ADDENDUM

**FINAL ENVIRONMENTAL IMPACT REPORT
(SCH No. 2012111083)**

**SAN JOAQUIN RIVER RESTORATION PROGRAM:
SALMON CONSERVATION AND RESEARCH FACILITY AND
RELATED FISHERIES MANAGEMENT ACTIONS PROJECT**

March 2015

Figure 2-3: Detailed Site Plan for the Salmon Conservation and Research Facility
 SCARF and Related Management Actions Project
 Draft Environmental Impact Report

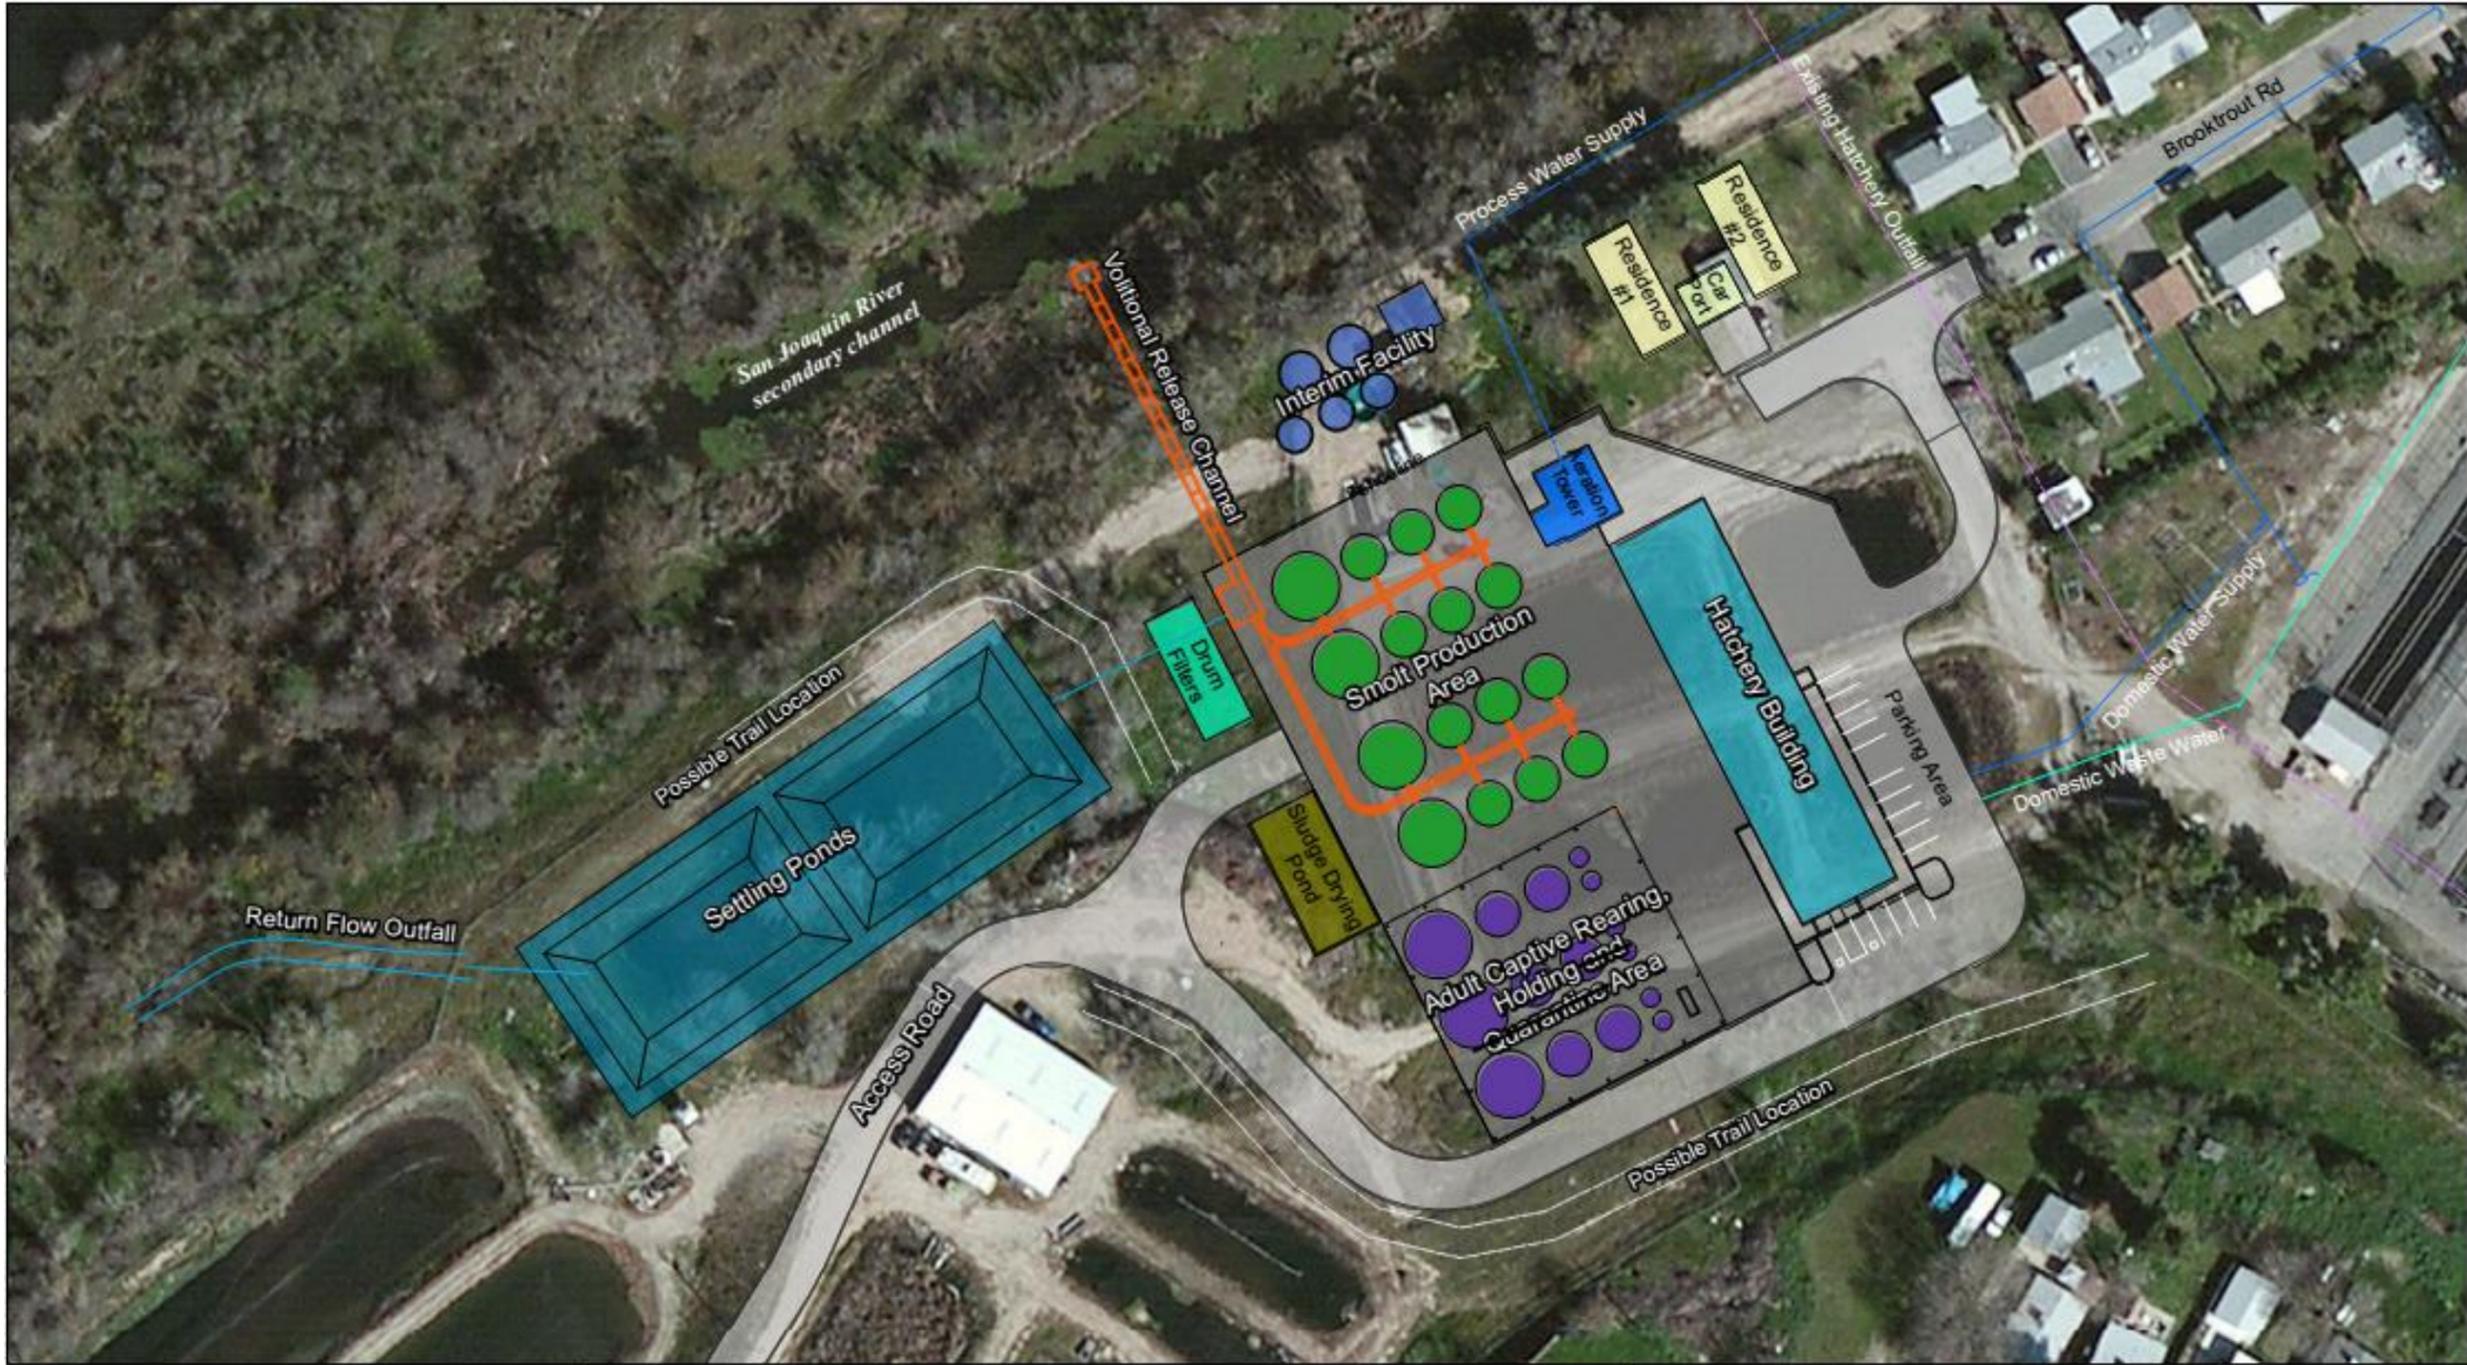
A corrected version of Figure 2-3, page 2-11 is shown on page 7 of this document.

Adult Captive Rearing and Holding and Quarantine Area: This would be a canopy-covered area consisting of six 8-foot, six 20-foot, and three 30-foot diameter circular culture tanks (Figure 2-3). The 8-foot diameter tanks would be used for early feeding and juvenile segregations; the larger tanks would be used for rearing fish up to three years of age and adult holding, ~~and quarantine~~. The canopy above this area would be constructed of metal. The individual tanks would be covered with domes, netting, or other material suitable to prevent predation by birds and other animals, and to prevent escape. These tanks also would have bottom drains to continuously capture and convey waste out of the tanks and to the treatment system.

Figure 1. Flow requirements at the Interim Facility for flow-through versus recirculated water.

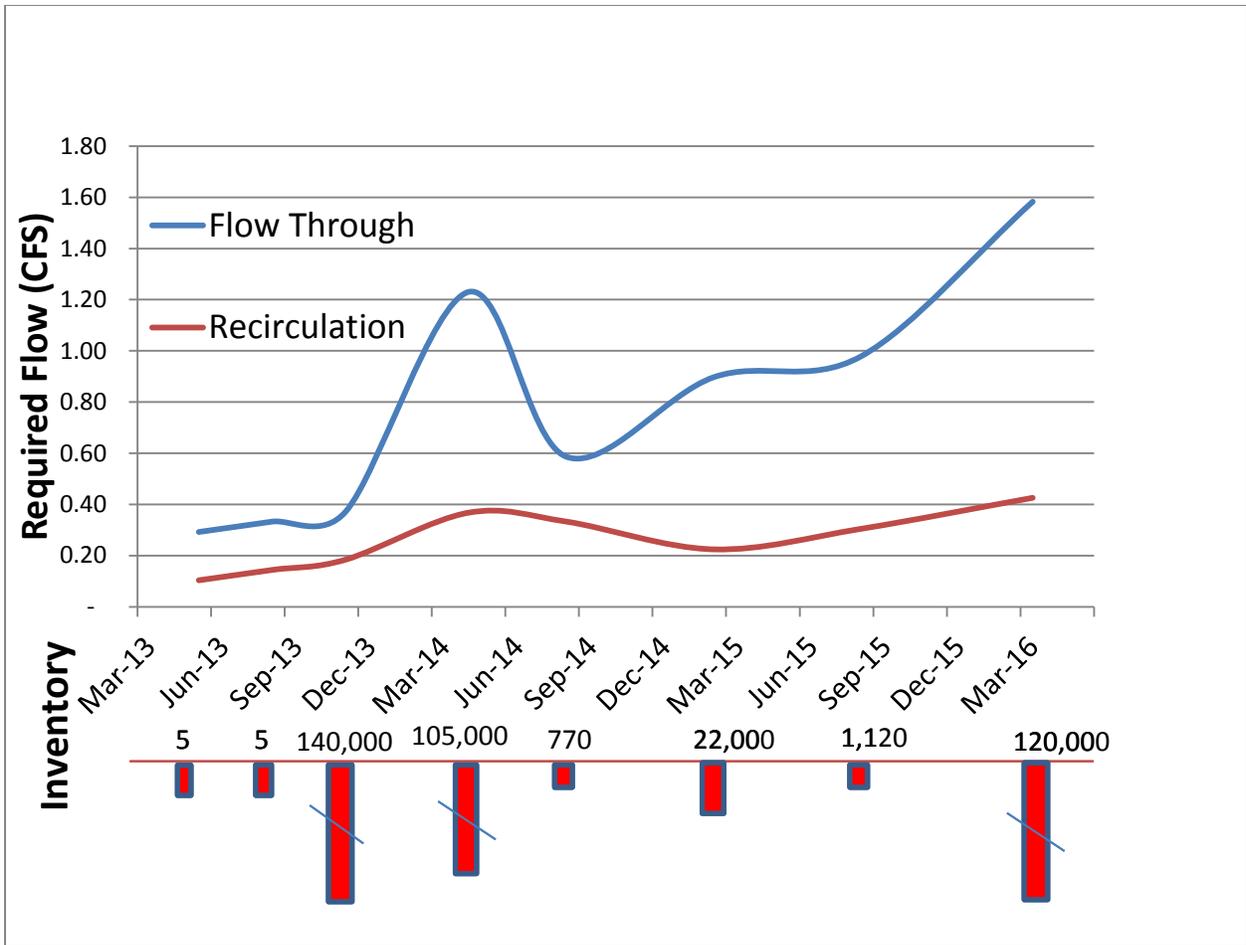
The water supply for the Interim Facility is diverted from the supply to SJFH that originates from Friant Dam. Currently, the SJRRP has an informal agreement with SJFH to use no more than 0.6 cubic feet per second (cfs) from the SJFH's existing supply of 35 cfs. In order for the Interim Facility to achieve production goals for the SJRRP until the SCARF is operational, it would need 1.8 cfs of water. SJFH is unable to provide the full amount of water needed by the Interim Facility because of its obligation to meet its trout stocking allotments for eleven counties. Water recirculation technology would allow the Interim Facility to meet its SJRRP obligations using only 0.6 cfs and not the full 1.8 cfs that would otherwise be needed (Figure 1).

Figure 2. Current layout of facilities in the fisheries shed at the Interim Facility.

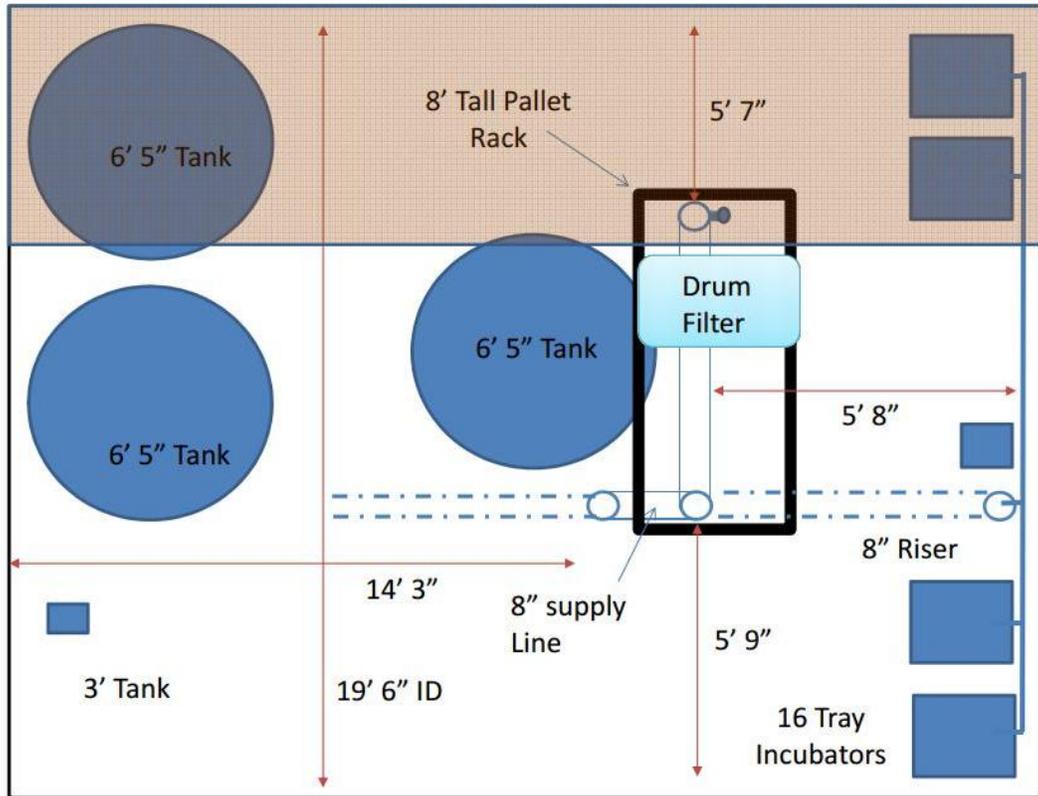
Existing components of the Interim Facility include a 500 square-foot metal fisheries shed containing a drum filter, four 16-tray vertical egg incubators, two 3-foot diameter circular tanks, and three 6-foot diameter circular tanks (Figure 2). Adjacent to the shed are two existing outdoor 16-foot diameter circular tanks, one of which would be relocated to avoid conflict with future SCARF construction (Figure 3). There are also two 8-foot by 20-foot shipping containers, one 8-foot by 20-foot fish tagging trailer and one portable toilet. There is currently no electrical power at the facility and a small mobile generator is used as needed.

Figure 3. Engineering drawings of expected layout for the recirculation project.

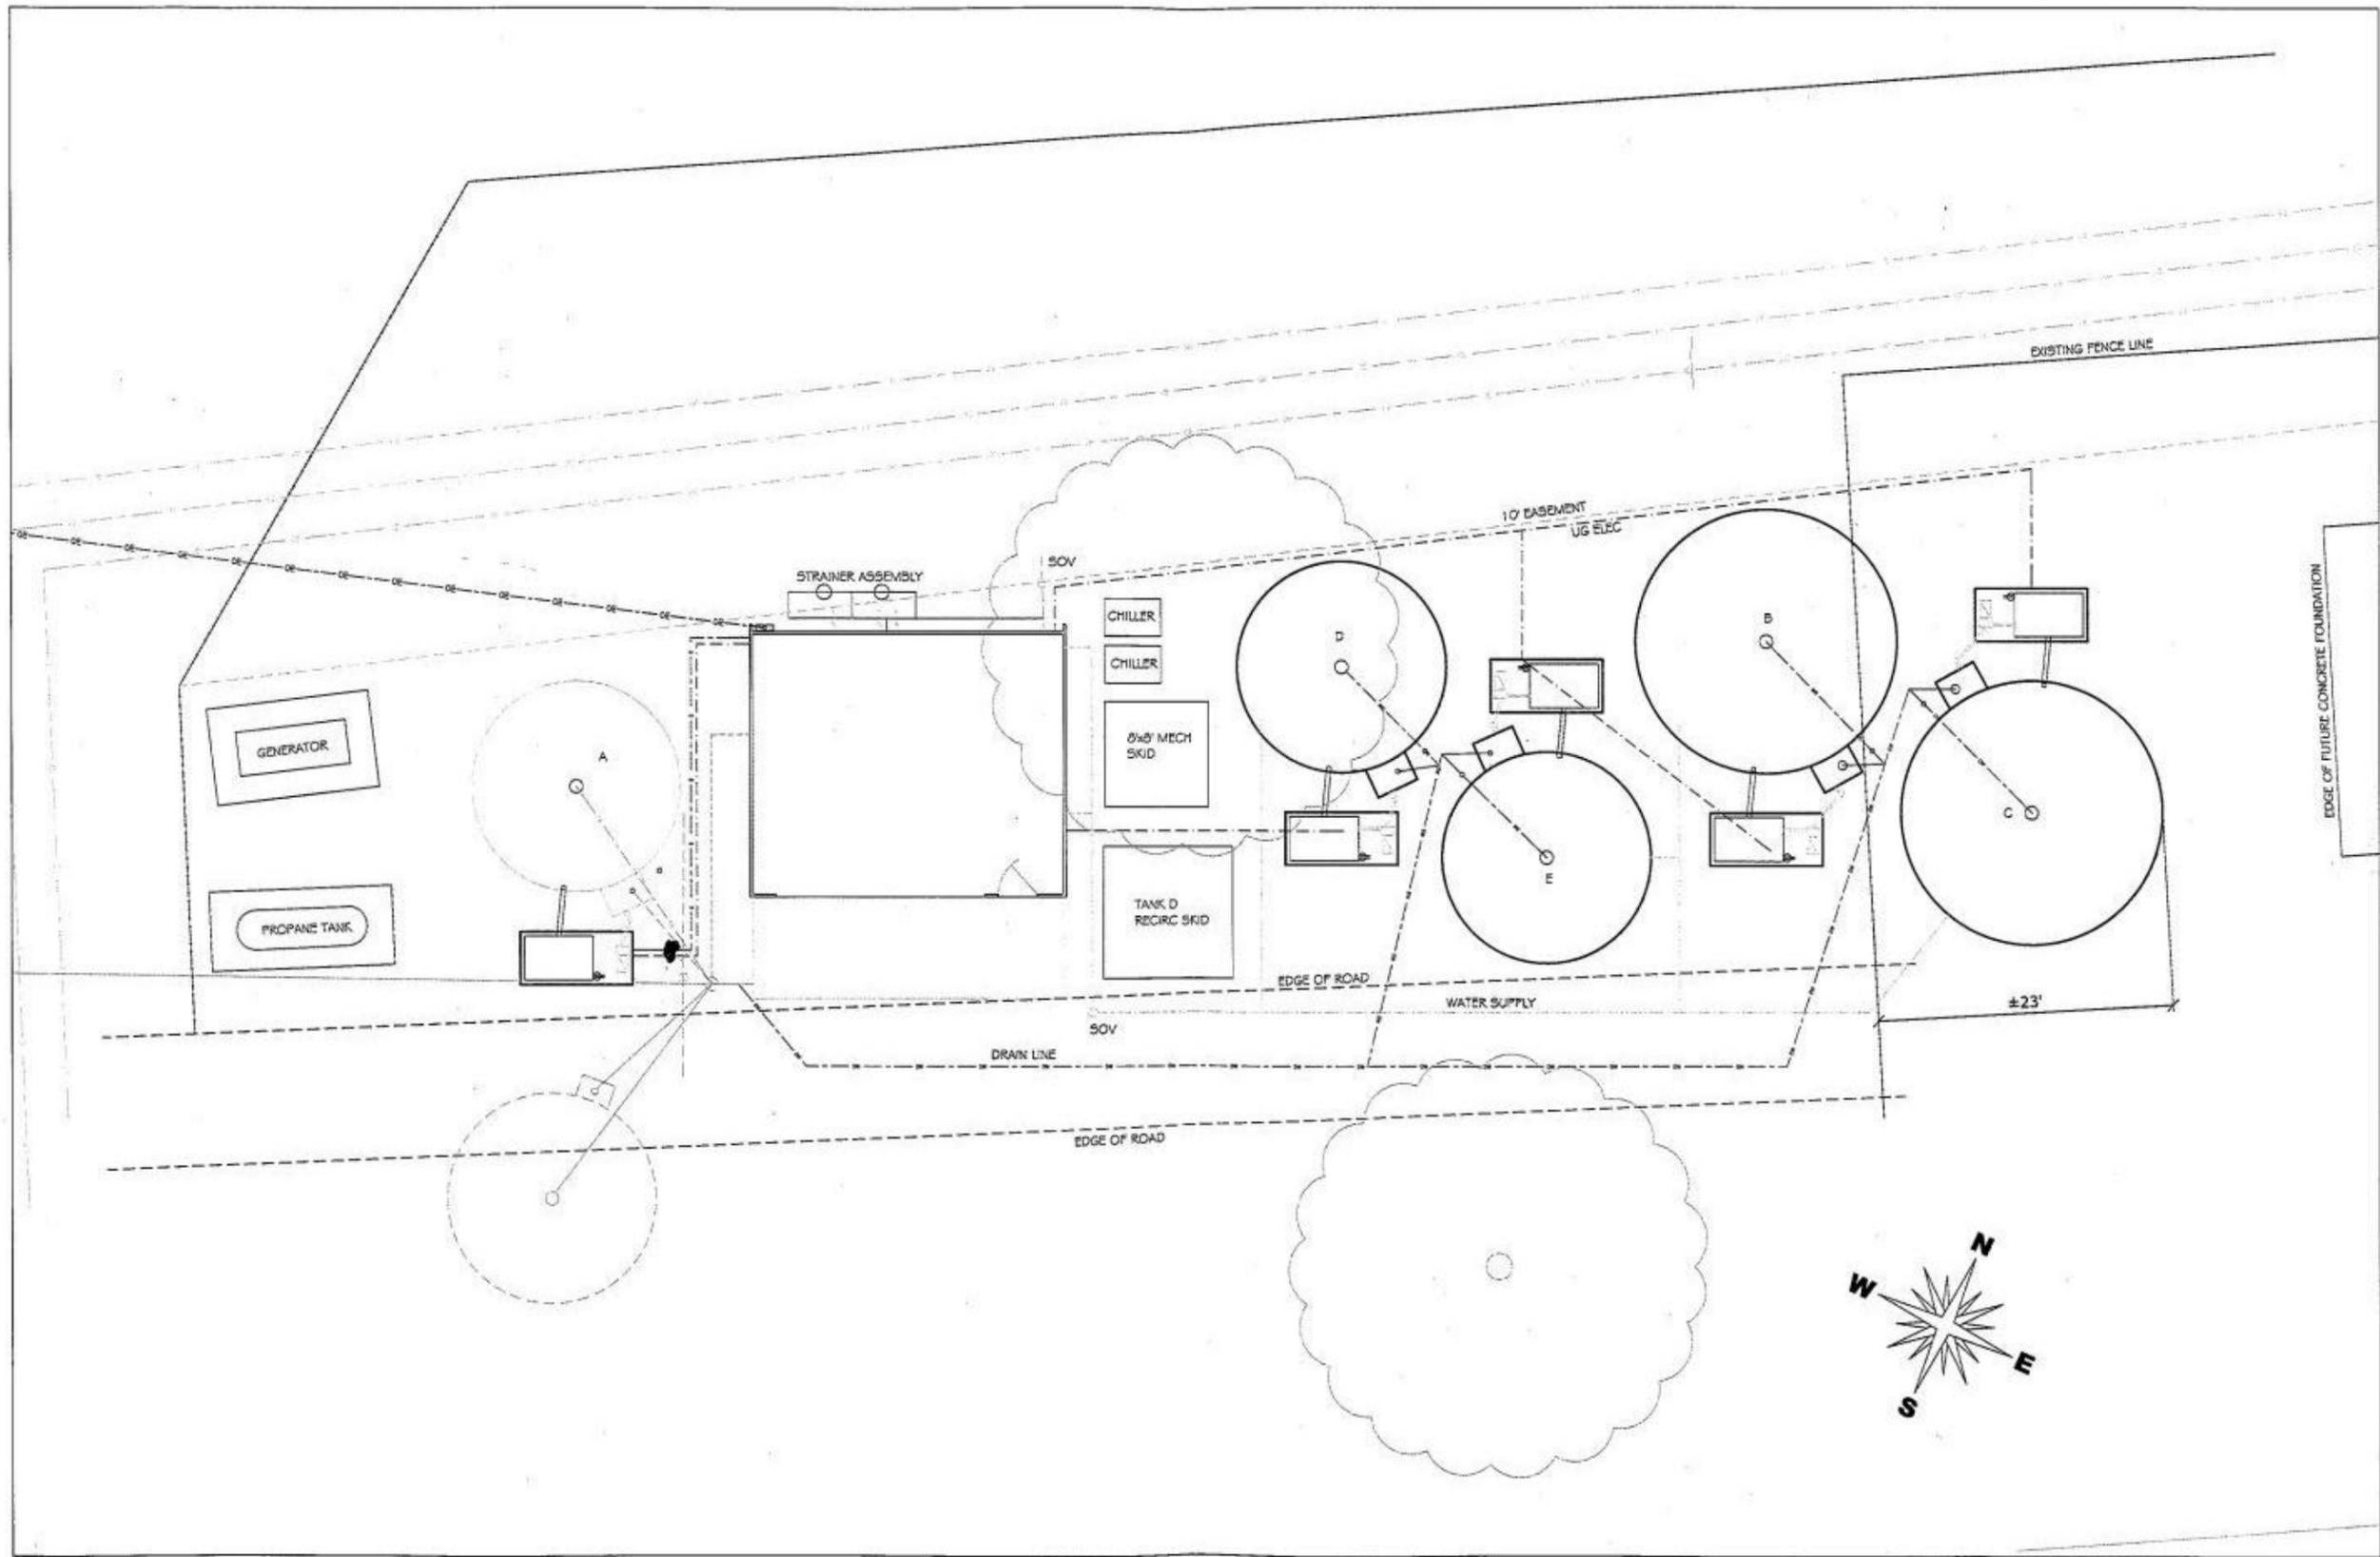
To provide sufficient space for future construction, one of the existing 16-foot diameter circular tanks would be relocated to the northeast of the shed. An additional 16-foot diameter circular tank and two 20-foot circular tanks would also be installed on the northeast side of the shed, totaling five large outdoor circular tanks. Locations of tanks, equipment and plumbing are shown in Figures 3 and 4, below. These tanks would be partially buried approximately 1.5 feet below ground surface. Tank installation activities would disturb a 3,000-square foot area and would require excavation up to a depth of 2.5 feet. Approximately 60 cubic yards of sand and/or gravel would be used as a foundation for the tanks (1 foot deep) and to line trenches for associated plumbing. Recirculation equipment would be placed at or above ground level, with the exception of underground plumbing and electrical conduit.
